**Informal Consultation
New & Amended Parking Restrictions
School Lane, Plaxtol**

I am (in favour / not in favour)* of the Borough Council's proposals for changes to the on-street parking arrangements for School Lane, Plaxtol, shown on plan DD/583/9

Revision	Date
STREETSCENE, LEISURE & TECHNICAL SERVICES	
Transportation Team Gibson Building Gibson Drive Kings Hill West Malling Kent ME19 4LZ Tel: 01732 844522 Fax: 01732 876317	
Project Title Local Parking Plan - Phase 10 Informal consultation	
Drawing Title Plaxtol School Lane	
Drawn ACB	Checked AY Date 6/2018
Scale 1 : 1000 @ A4	
Drawing No. DD/583/9	Rev

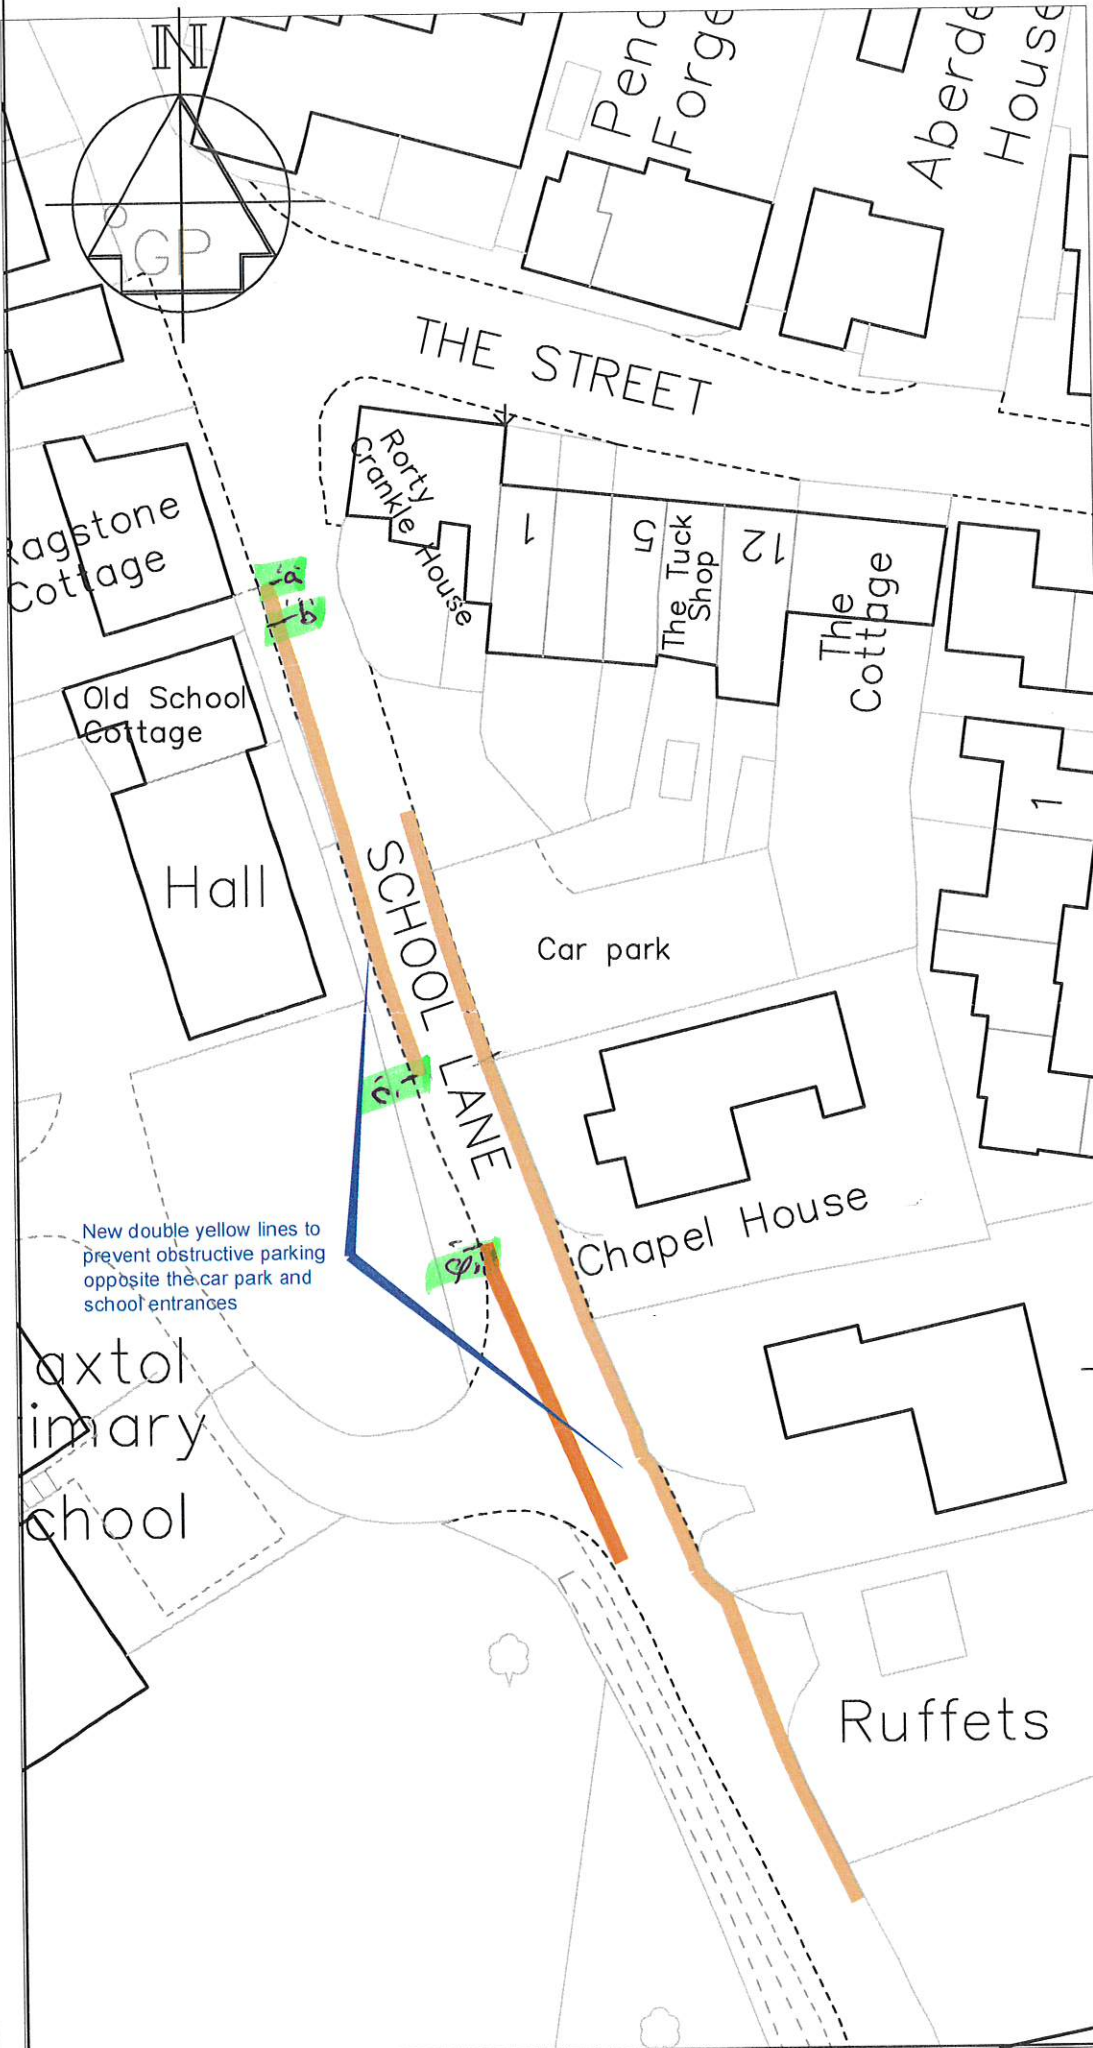
supportive of traffic control in school lane, however we are not in favour of the current proposed restrictions shown in plan reference DD/583/4. Our comments/queries are set out below.

- i, the proposed "No waiting at any time" (double yellow lines) currently shows the restriction in front of our property where we take frequent deliveries including Oil, logs and other items we cannot get through the front door. It is the only place on our property to access our fuel tank. We derive beneficial use from being able to park at this point. We would request that the restriction stops at position marked "b" (see attached plan) rather than "a".

- ii, has consideration been given to how cars will enter/exit the car park opposite the village hall. It seems sensible that the double yellow restriction should continue from point "c" to point "d" (see attached plan) to allow enough space for cars to turn into this car park.
